DRI REGIONAL REVIEW FINDING

Name of Proposal: 2023 Amsterdam Walk DRI 4065

Description: Project Description: A DRI review of a proposal to construct a mixed-use project with 900 residential units, 400,000 SF of office space, and 90,000 SF of ground floor retail space on the 11.4 site of the current Amsterdam Walk development on Amsterdam Avenue fronting the Beltline Northeast Trail in the City of Atlanta.

DATE: 11/20/2023
PROJECT NO: 019292043
TITLE: DRI SITE PLAN
SHEET NUMBER: C0-20

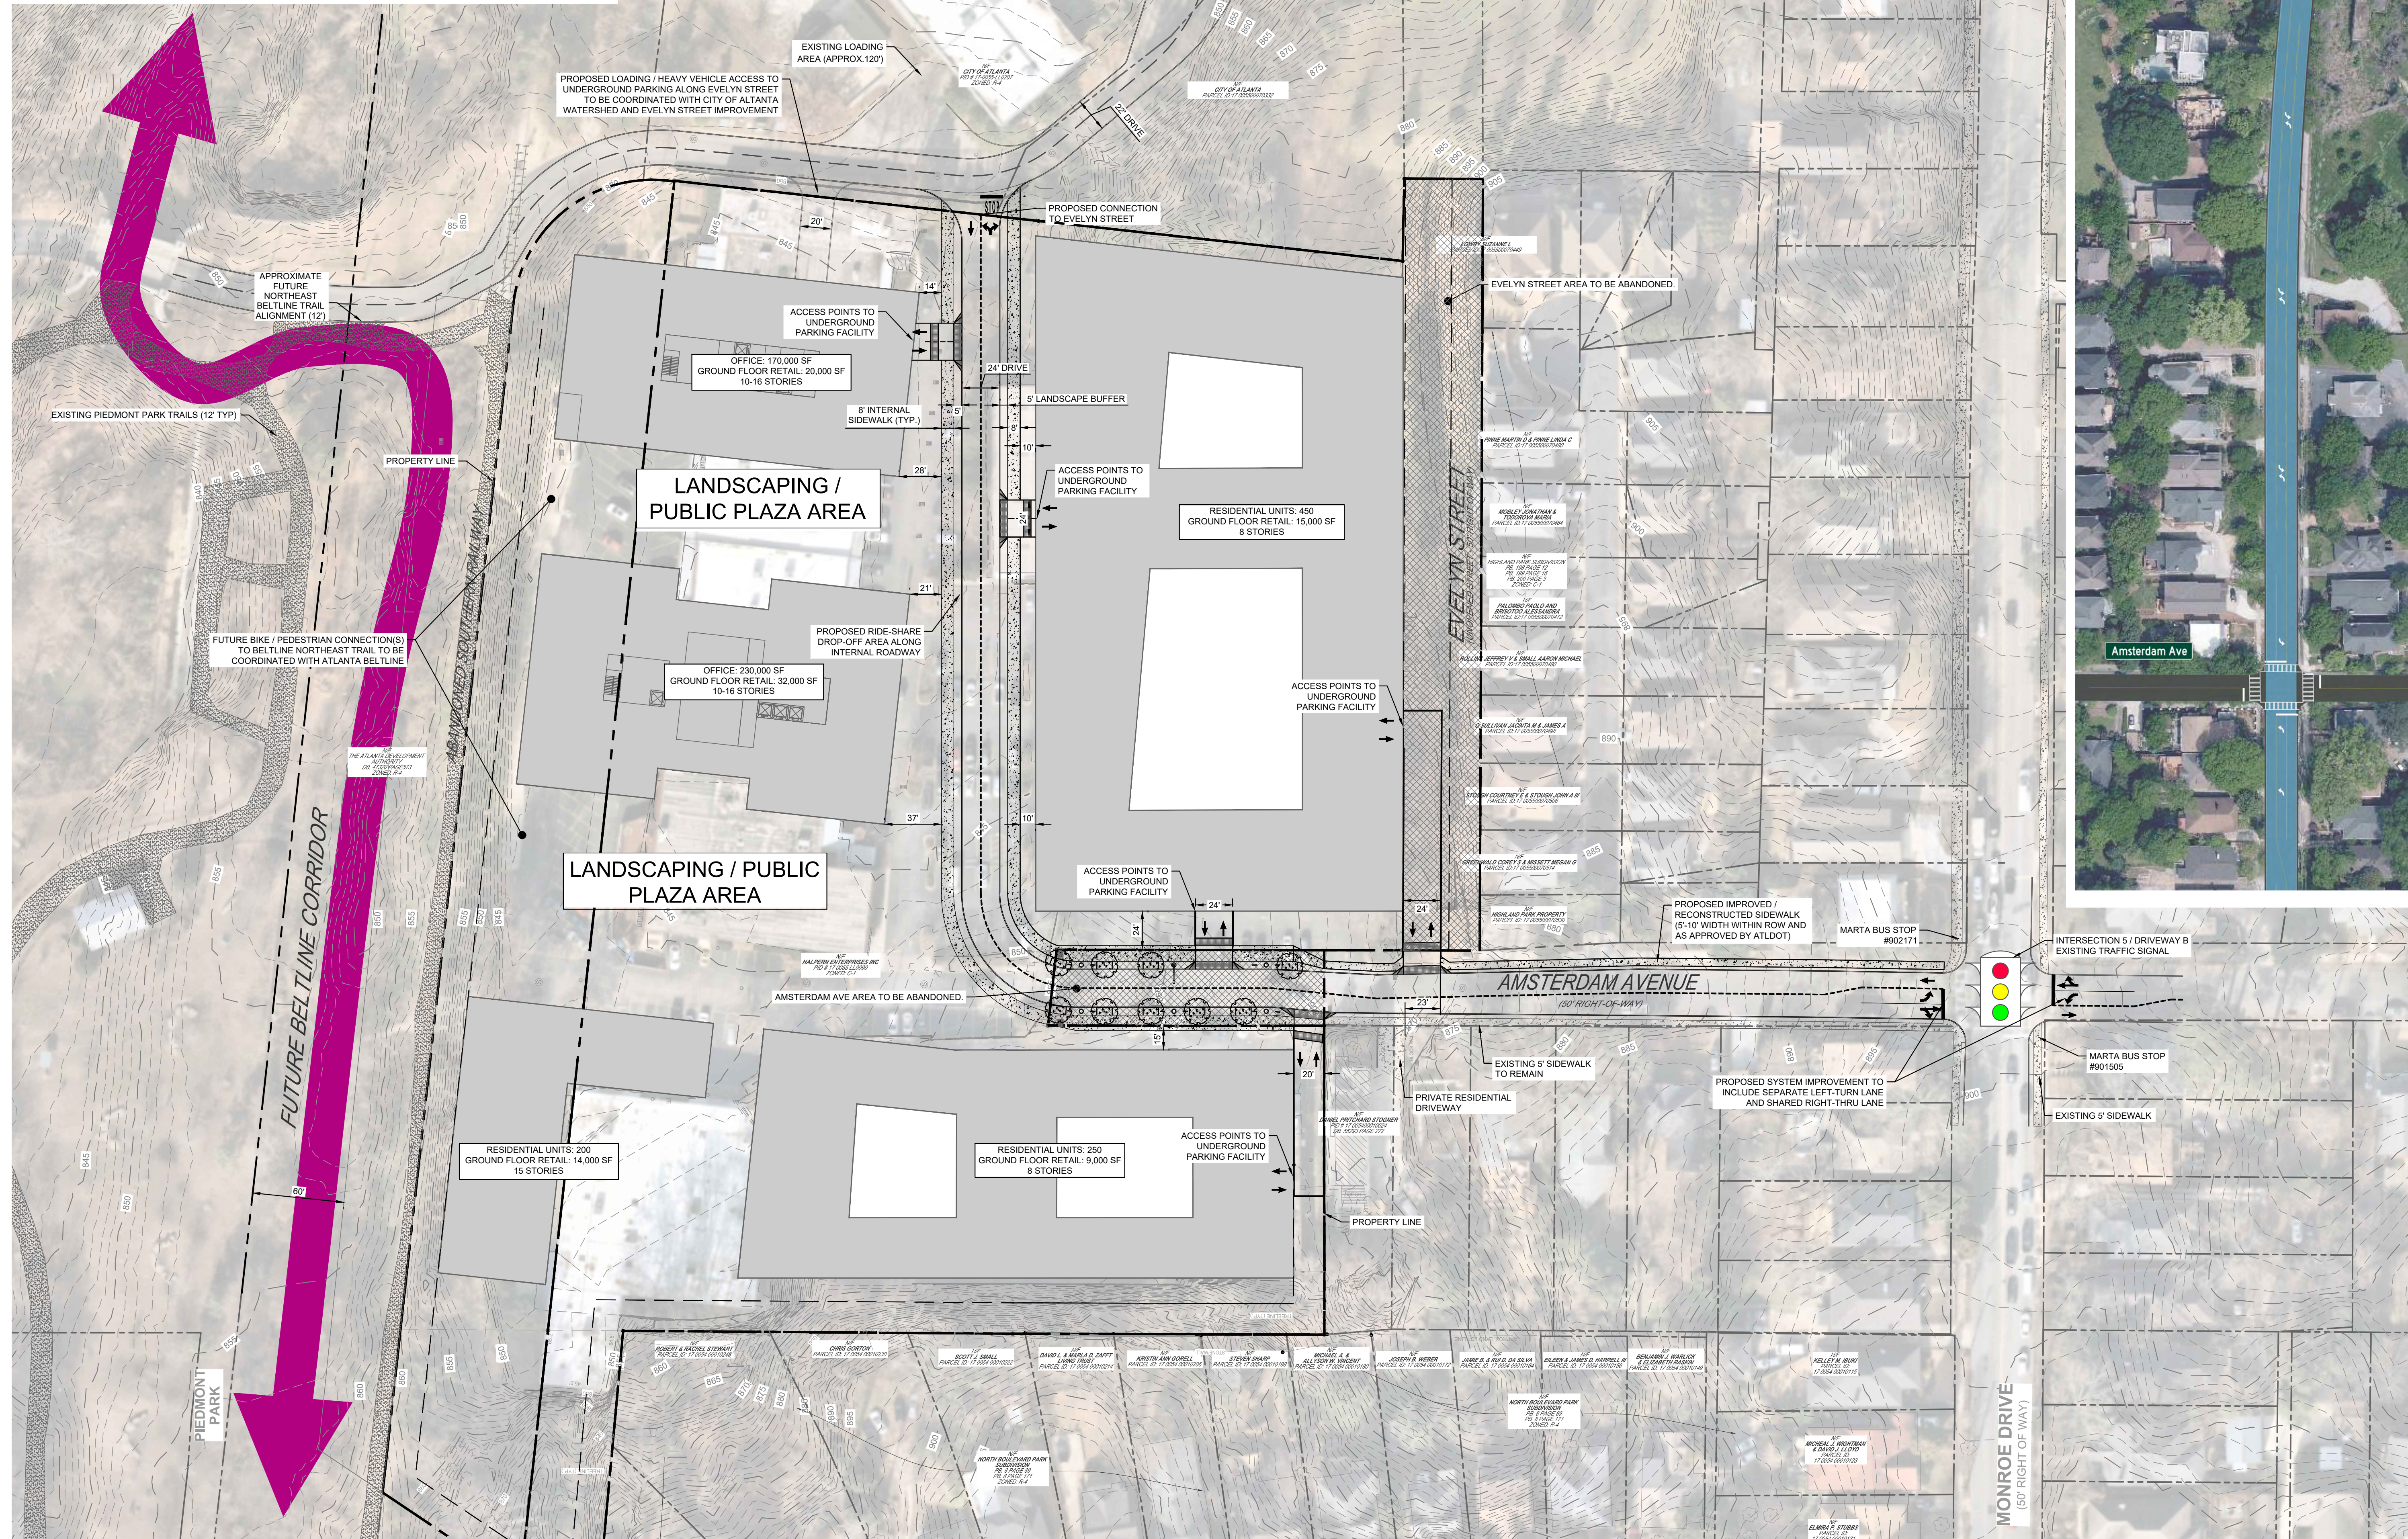
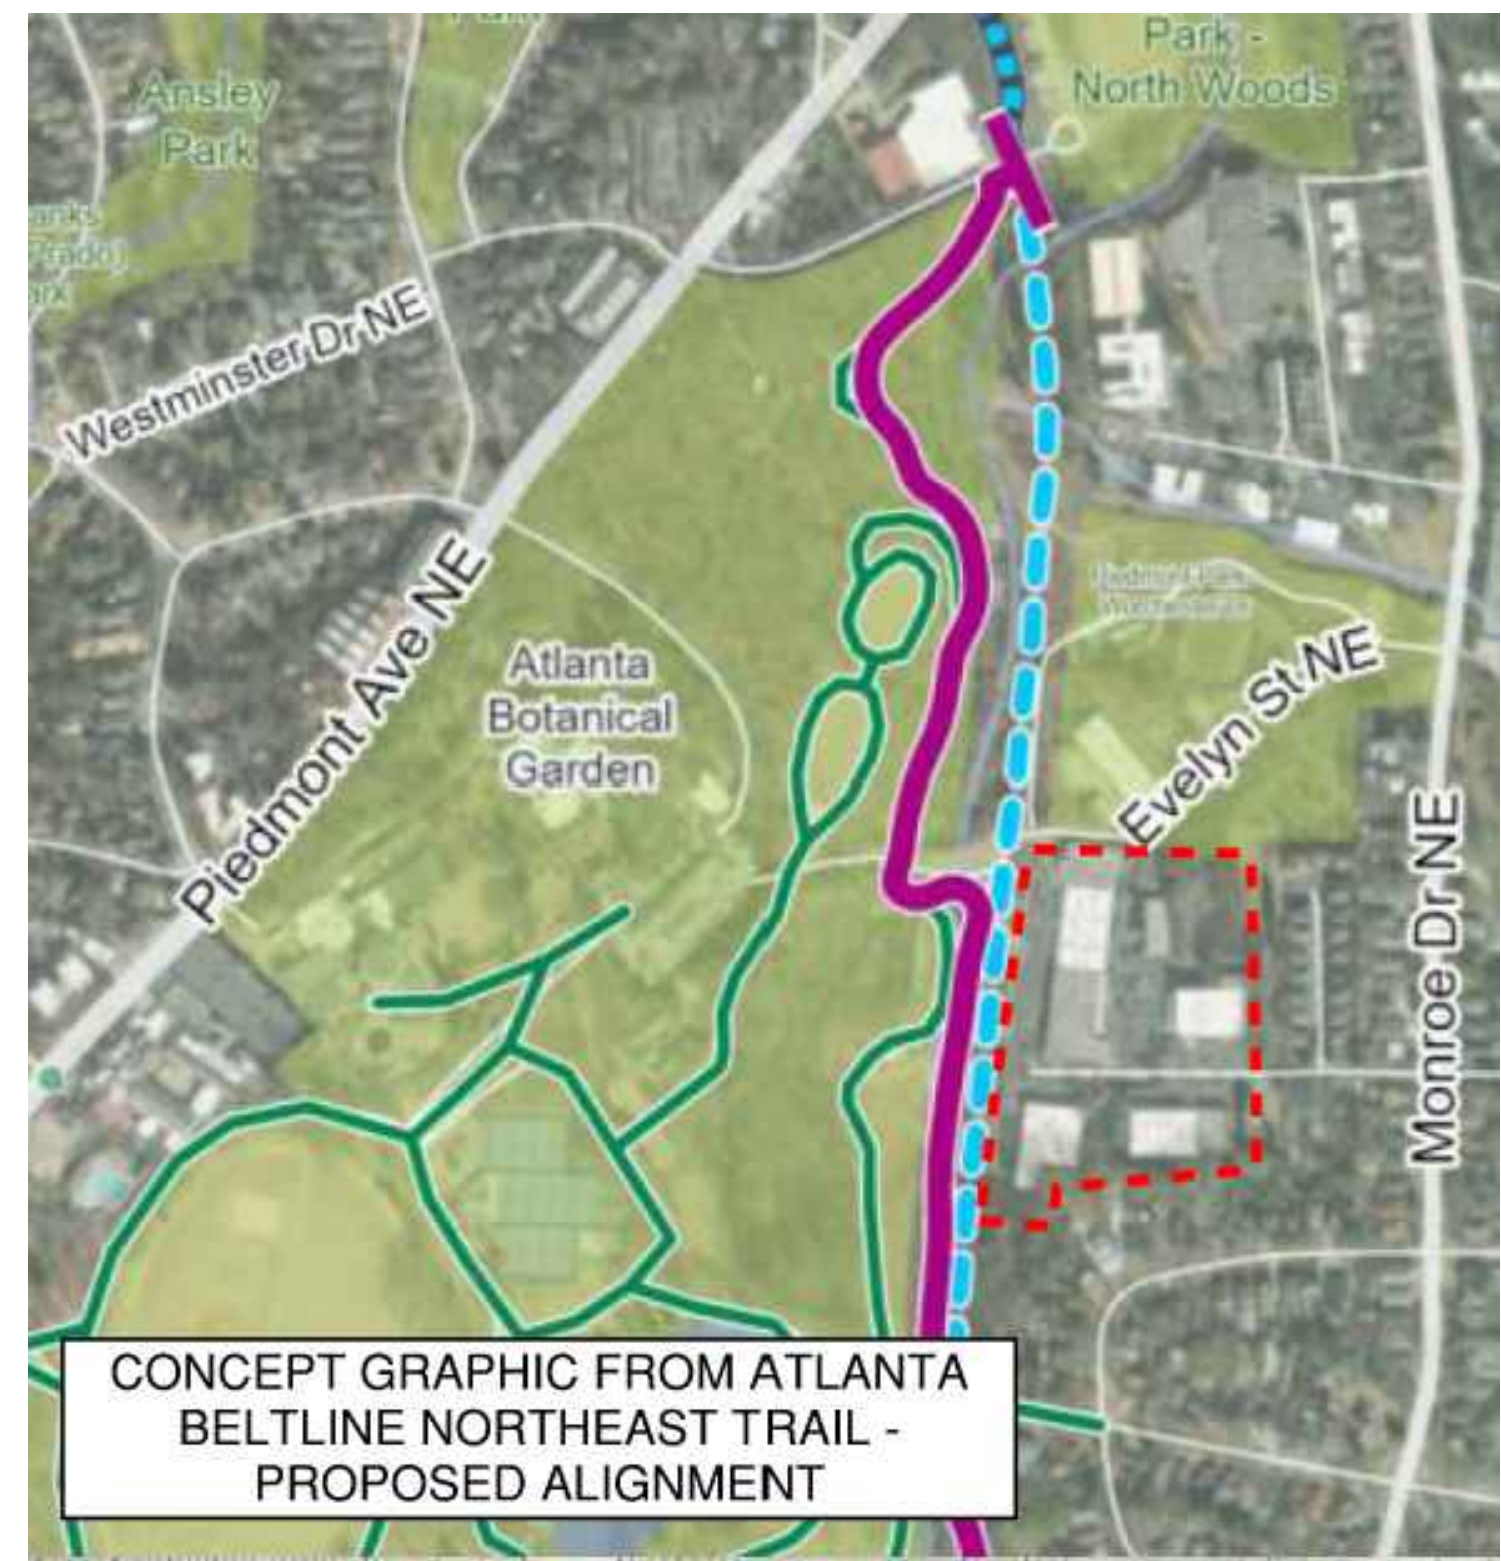
The project's treatment of the extensive Beltline frontage will need to be carefully coordinated with the City of Atlanta and the Beltline organization.

The proposed expanded sidewalk on the north side of Amsterdam Avenue will be critical to ensuring easy and inviting pedestrian access from the surrounding neighborhood to the east and the MARTA stops on Monroe Drive.

Pedestrian, bicycle and vehicular access to the project from Monroe Drive should be carefully coordinated with the City of Atlanta's pending plans for the Monroe Drive Complete Streets project.

The proposed expanded sidewalk on the north side of Amsterdam Avenue will be critical to ensuring easy and inviting pedestrian access from the surrounding neighborhood to the east and the MARTA stops on Monroe Drive.

Pedestrian, bicycle and vehicular access to the project from Monroe Drive should be carefully coordinated with the City of Atlanta's pending plans for the Monroe Drive Complete Streets project.

Care should be taken to ensure that the constructed development provides an interconnected, functional, clearly marked and comfortable pedestrian experience on all driveways, paths, entrances, and parking areas. To the maximum extent possible, new driveways and intersection corners where pedestrians will

cross should be constructed with minimal curb radii to reduce speeds of turning vehicles and decrease crossing distances for pedestrians.

Note: Proposed bike/pedestrian bike connections shown on westside of site plan to be coordinated with the Atlanta Beltline.
